Addendum #7

CONSIDER IN YOUR RESPONSE/BID THE FOLLOWING ITEMS OF ADDITION, DELETION OR CLARIFICATION. INDICATE IN THE SPACE PROVIDED ON THE RESPONSE/BID FORM THAT YOU HAVE RECEIVED AND INCLUDED FOR THE REQUIREMENTS OF THIS ADDENDUM. SICKKIDS MAY, IN ITS SOLE DISCRETION ANSWER SIMILAR QUESTIONS FROM VARIOUS RESPONDENTS ONLY ONCE.

RE: QUESTIONS AND ANSWERS, SPECIFICATIONS, DRAWINGS AND DOCUMENTS

Drawing No.
AU-02-BW-02

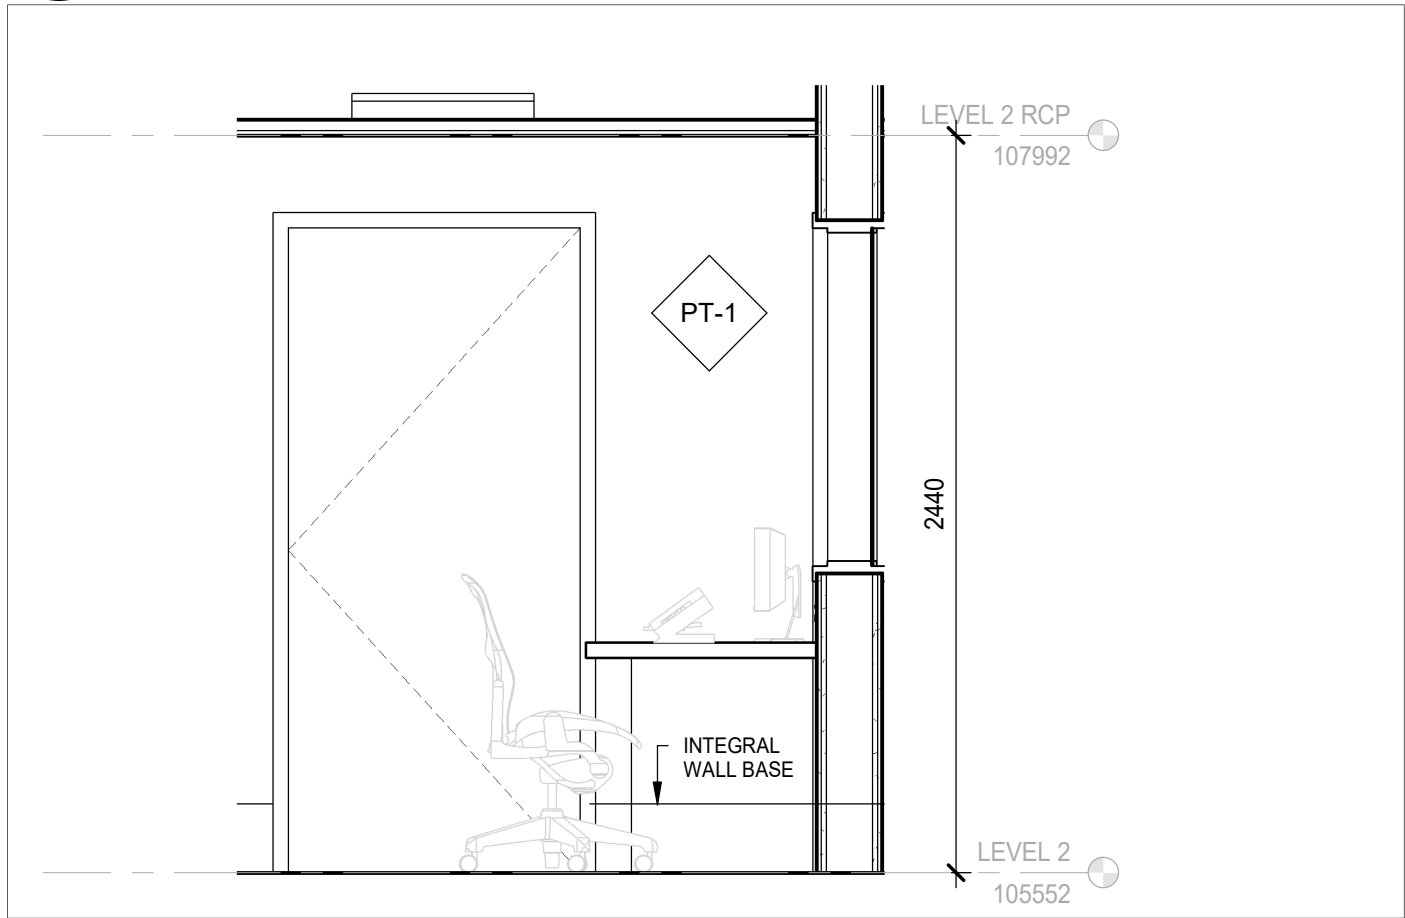
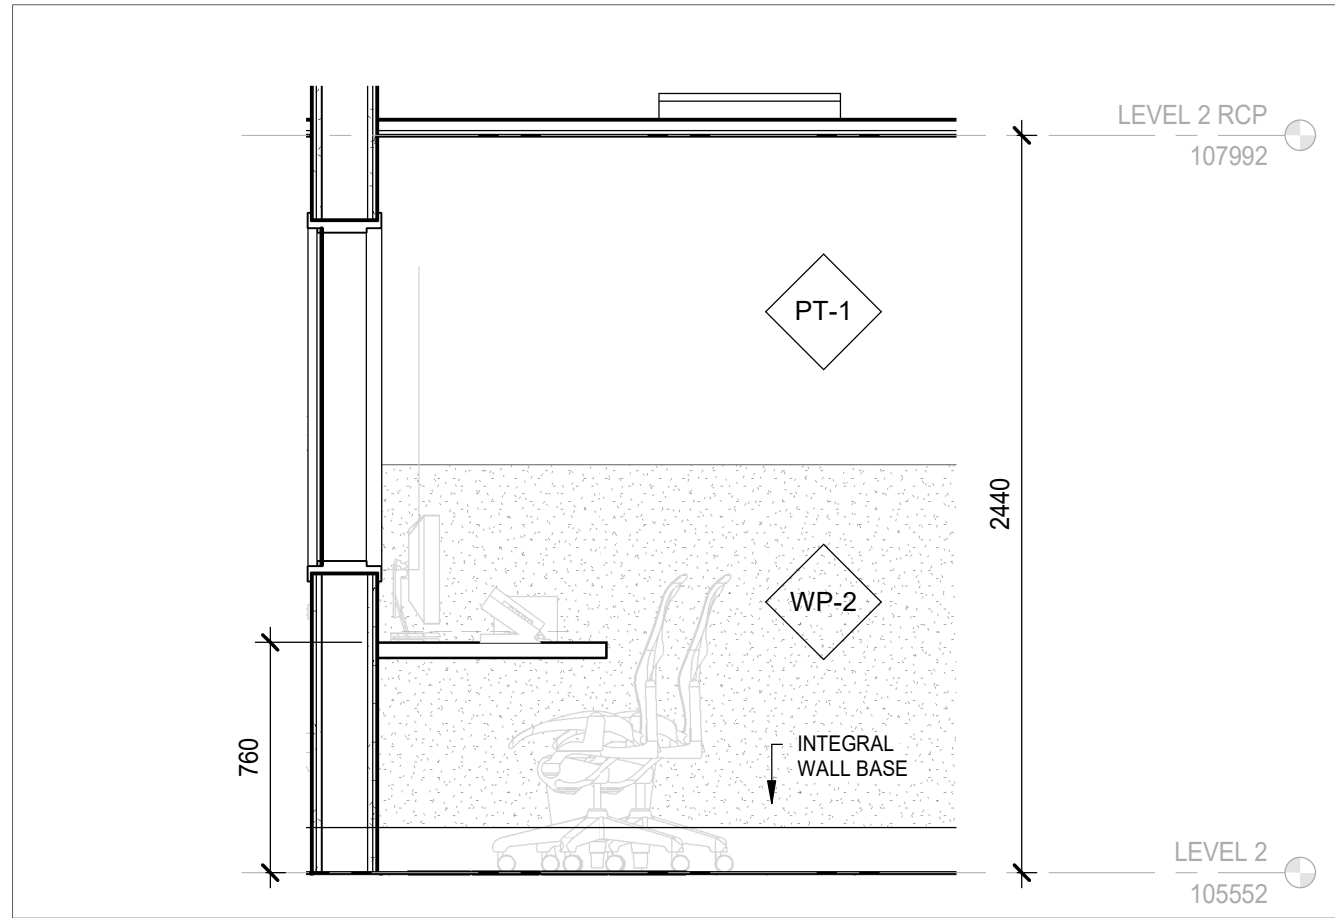
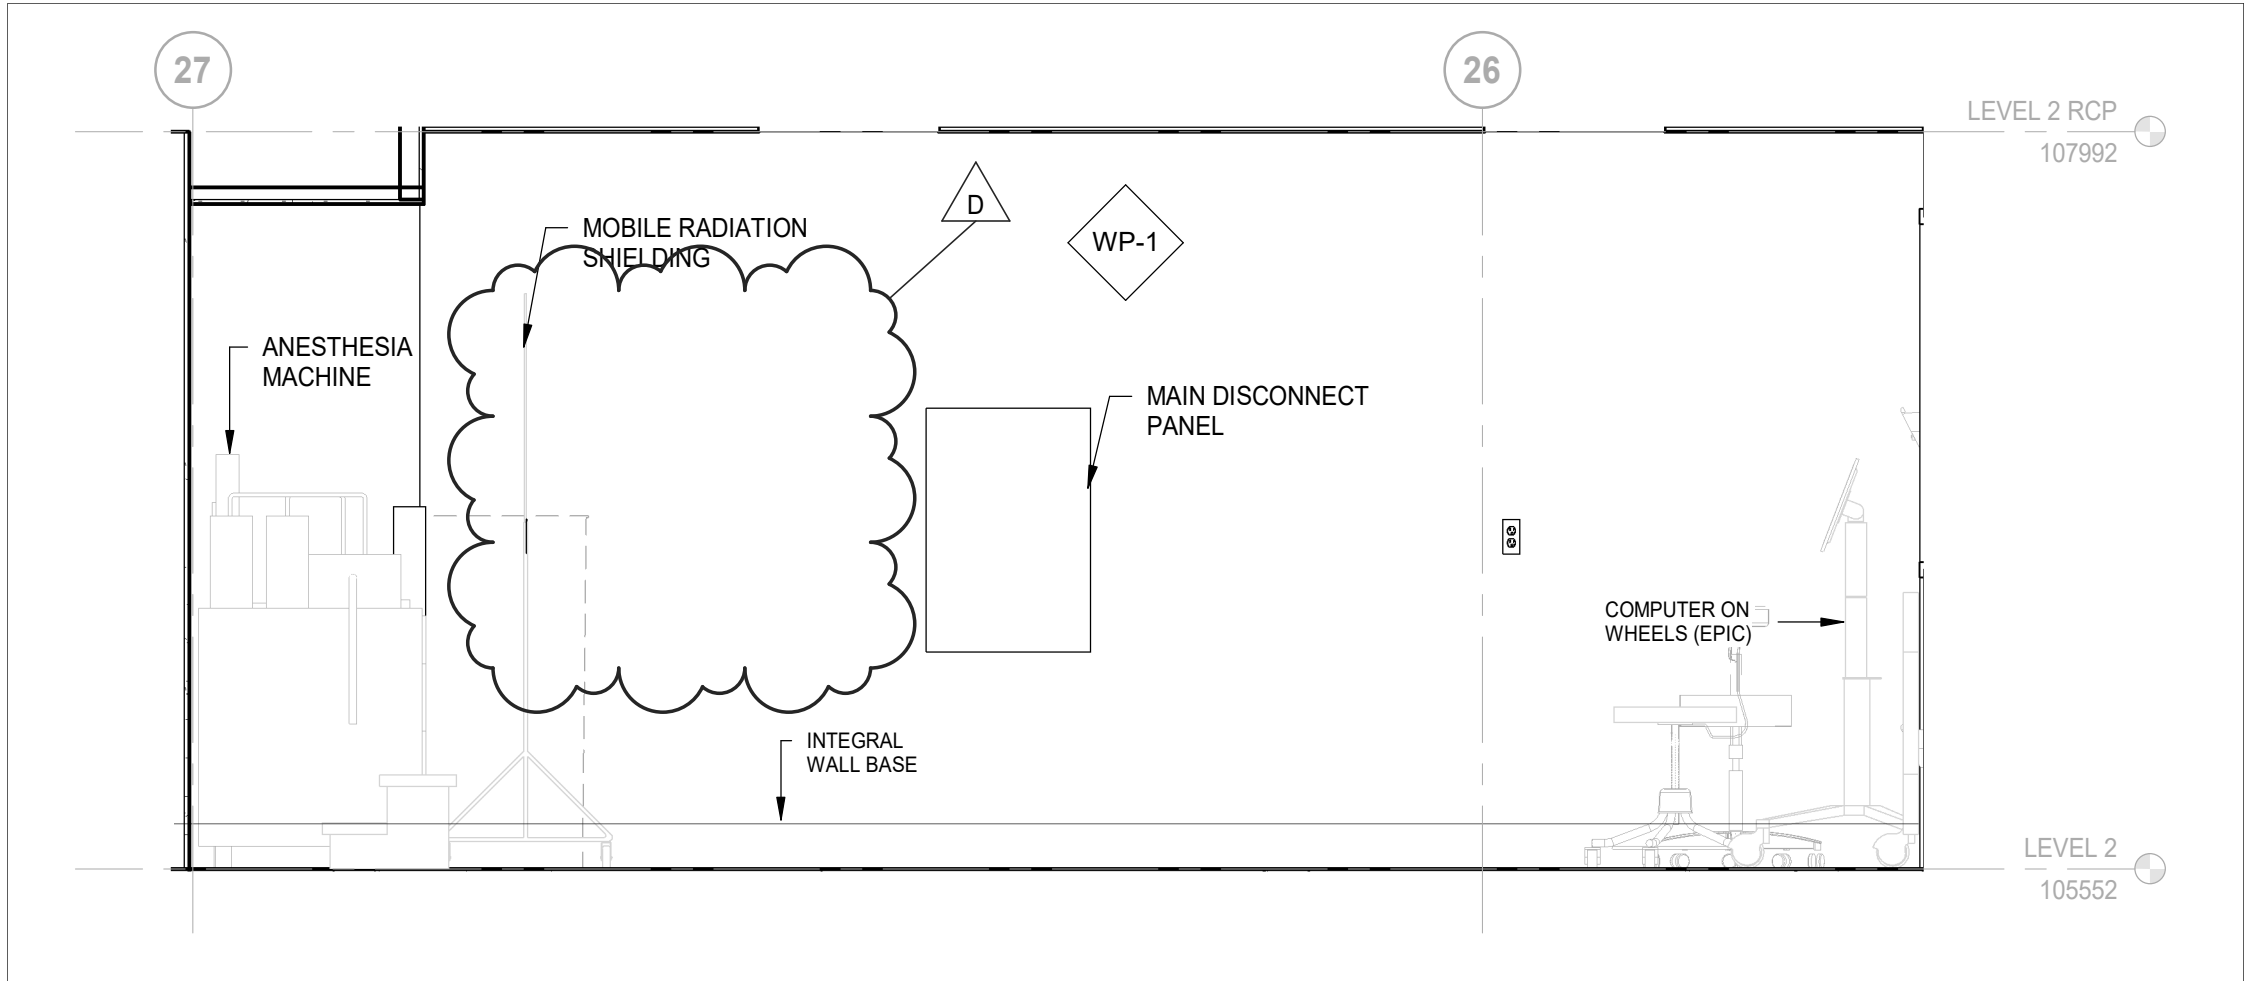
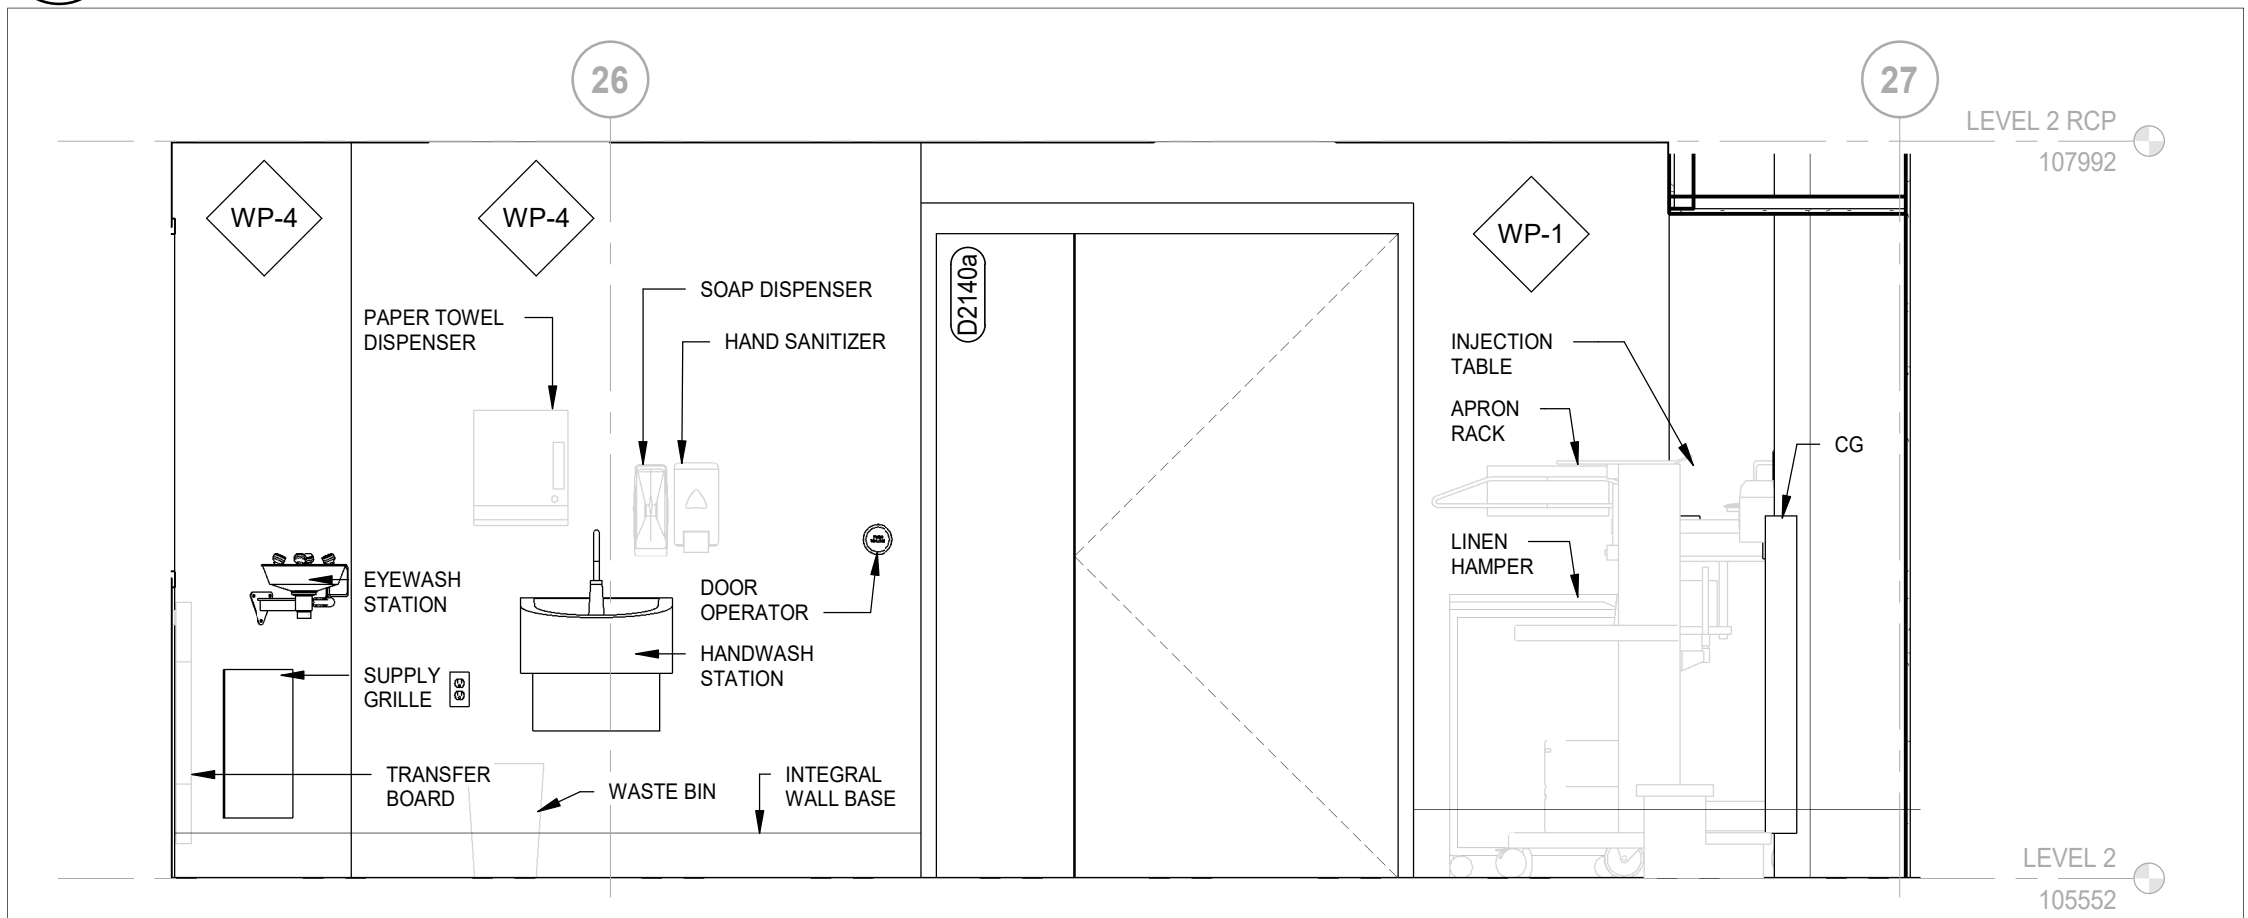
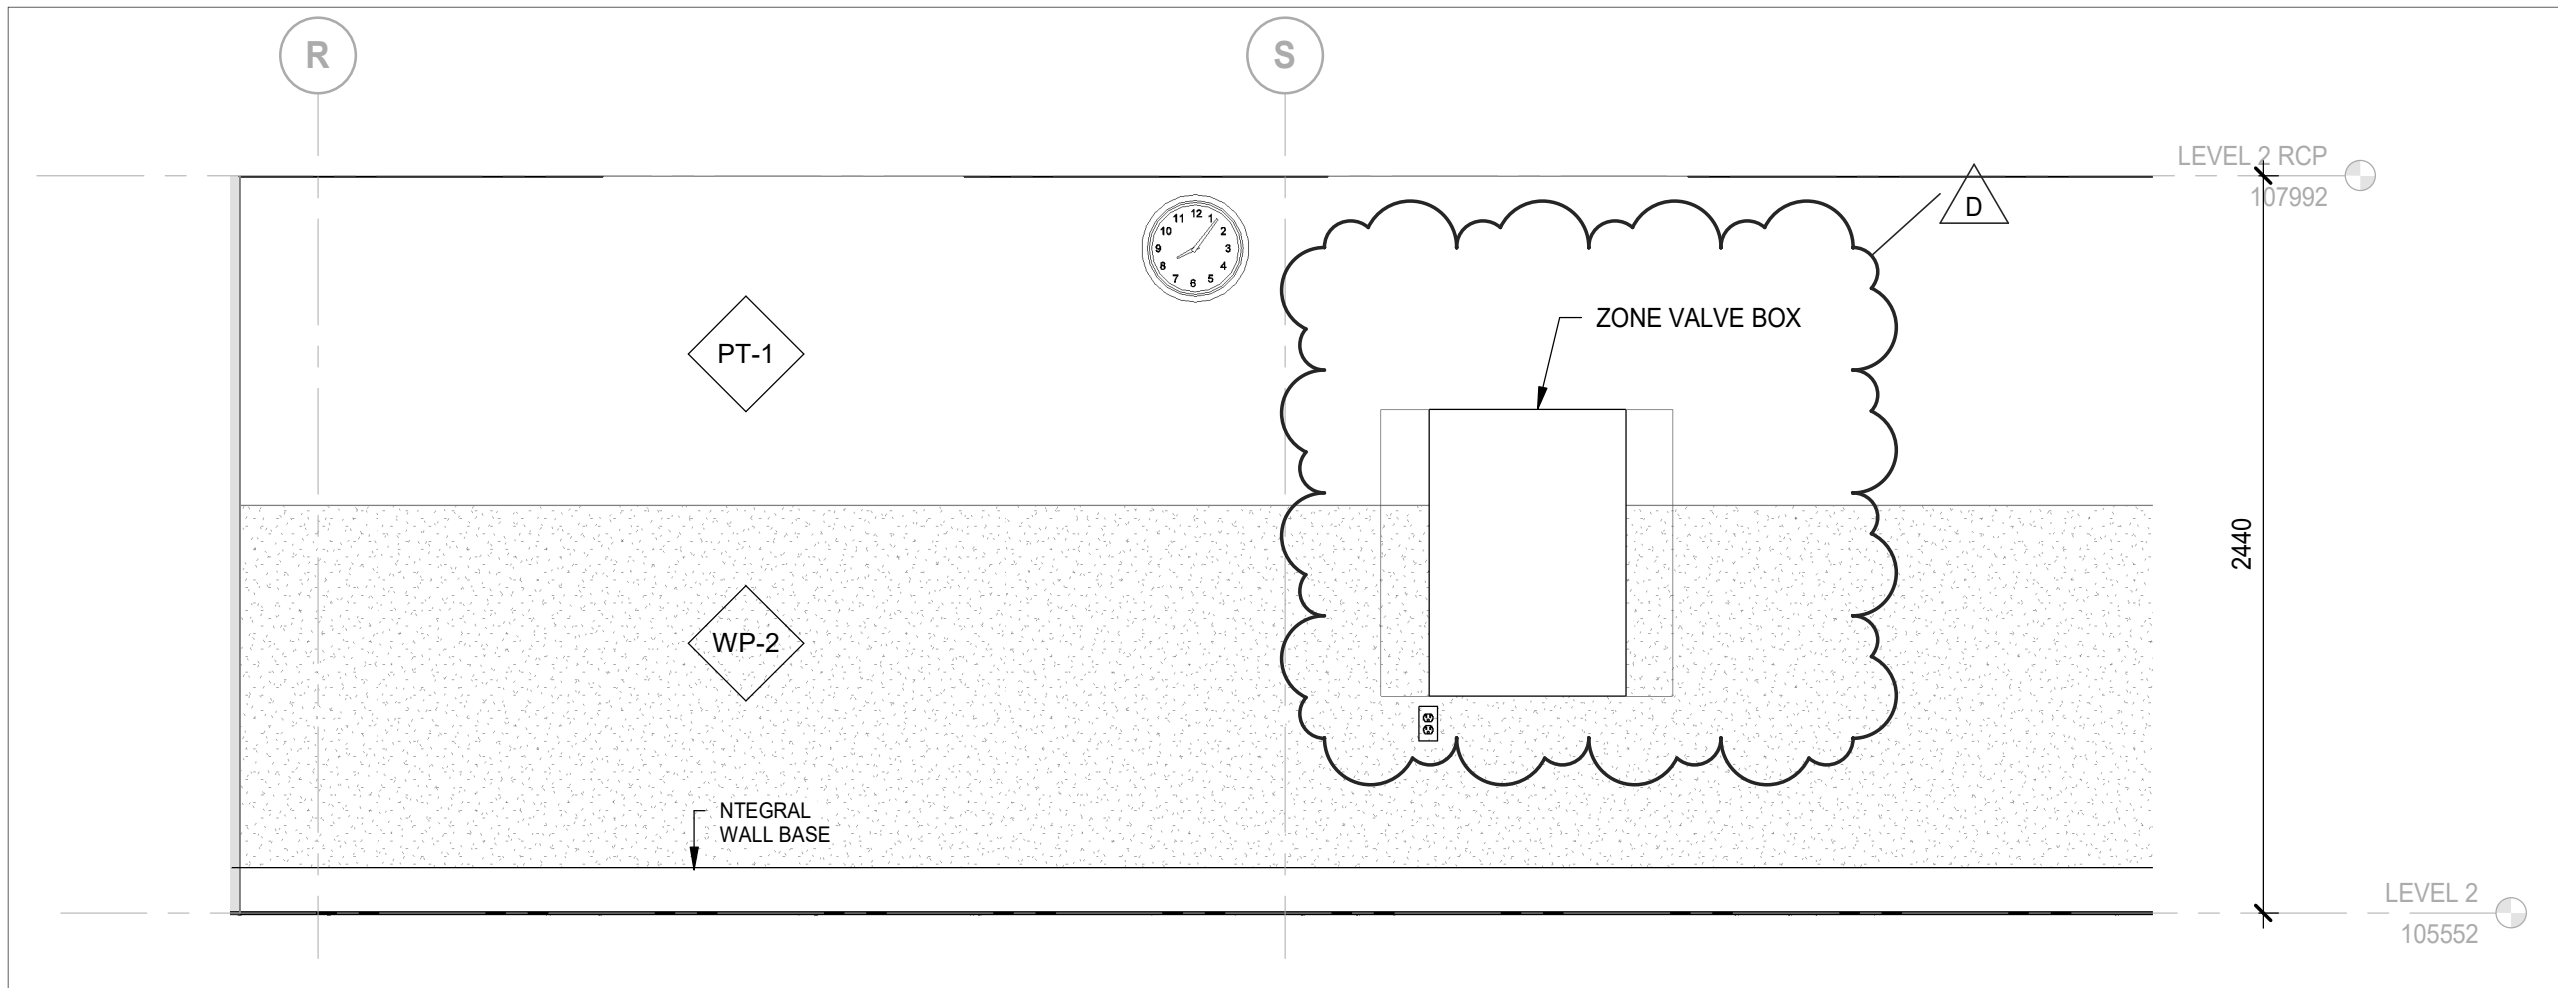
- .5 Drawing AB-02-BW-02 ENLARGED ELEVATIONS
Removed Valve Box and new location of Valve Box
 - .6 Drawing AU-02-BW-05 PLAN, SECTION AND MILLWORK DETAILS
Updated information on Plam.
